SUBMITTAL DRAWINGS
 Model ACM (Air Defrost)
UNIT COOLERS

Project: Webster University ISB Arch/Engr: Cannon Design Customer: Paric Construction Identity: _____ Item No. _____	Location: _____ Order No. _____ Model No. _____ Qty: _____	Date: 2/7/2017 by: JKB ☒ for approval ☐ for record
--	--	--

RE: Submittal 130383-006 for the Controlled Temperature Room at Webster University Science Building

Copies	No.	Description
1 PDF	130383E02A	(Submittal No.'s:) (R&B-CXSRG) - Resubmittal
		(Cannon #130383- 006 REV002)-(Paric #15051-0490)-(WES #607)
		➤ Cold Room Product Data

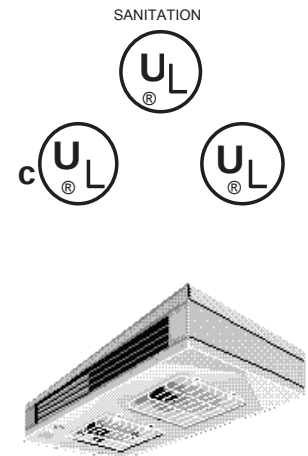
The evaporator coil and its capacity are shown in the product data and its location indicated on our shop drawing. The evaporator coil has also been upsized to match the increased capacity of the condensing unit as noted above. OK
